# CITY OF MERCER ISLAND

## STAFF REPORT

### SHORELINE SUBSTANTIAL DEVELOPMENT PERMIT

<b>Project No.:</b>	SHL23-026
<b>Description:</b>	A request for a Shoreline Substantial Development Permit with SEPA Review for the removal of a 35 square foot wooden dock and 25 linear feet of concrete bulkhead, construction of a new 650.75 square foot joint-use dock, and installation of two boatlifts.
<b>Applicant / Owner:</b>	Mark Kushino (Waterfront Construction) / Melanie Pritt (6027 32 <sup>nd</sup> St, LLC)
<b>Site Address:</b>	6025 & 6027 SE 32 <sup>nd</sup> St, Mercer Island, WA 98040; Identified by King County Assessor tax parcel numbers 370890-0042 & 370890-0040.
<b>Zoning District:</b>	Single Family Residential (R-15)
<b>Staff Contact:</b>	Molly McGuire, Planner
<b>Exhibits:</b>	<ol style="list-style-type: none"><li>1. Development Application, received by the City of Mercer Island on April 25, 2023</li><li>2. Revised Development Plan Set, dated August 29, 2022 and received September 5, 2023</li><li>3. Project Narrative, received May 25, 2023</li><li>4. SEPA Checklist, received April 25, 2023</li><li>5. Ecological No Net Loss Assessment Report prepared by Northwest Environmental Consu

REFERENCE #:	
APPLICANT: 6027 LLC c/o MELANIE PRITT	
PROPOSED: NEW JOINT-USE DOCK	
SHEET: 5 OF 10	NEAR/AT: LAKE WASHINGTON
DATE: 08/29/2022	DWG#: 22-32020-A5-5

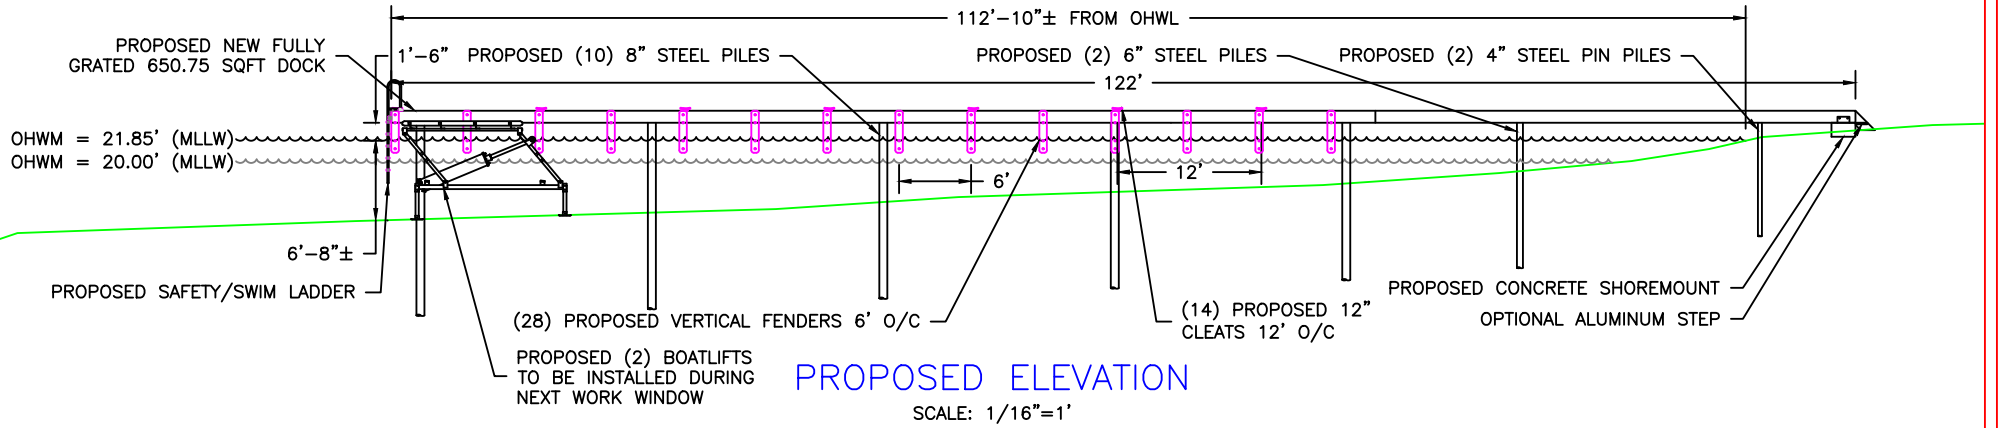
**Staff Analysis:** The proposed moorage facility would be built within 10 feet from the lateral line, subject to the agreement between adjoining property owners (**Exhibit 2, Sheet 5; Exhibit 7**); therefore, this requirement is met.

**Staff Analysis:** The proposed moorage facility extends approximately 112 feet 10 inches waterward from the OHWM. The water depth at the end of the dock is 6 feet 8 inches (**Exhibit 2, Sheet 5**); therefore, this requirement is met.

**Staff Analysis:** The width of the proposed moorage facility within 30 feet waterward from the OHWM is 4 feet (**Exhibit 2, Sheet 5**); therefore, this requirement is met.

**Staff Analysis:** The width of the proposed moorage facility more than 30 feet waterward from the OHWM is 6 feet (**Exhibit 2, Sheet 5**); therefore, this requirement is met.

**Staff Analysis:** The combined water frontage of the two adjoining single-family lots is 100.14 feet (**Exhibit 2, Sheet 5**); therefore, this requirement is met.

**Staff Analysis:** The proposed development would be 4 feet wide within 30 feet waterward from the OHWM and 6 feet wide greater than 30 feet waterward from the OHWM (**Exhibit 2, Sheet 5**); therefore, this requirement is met.
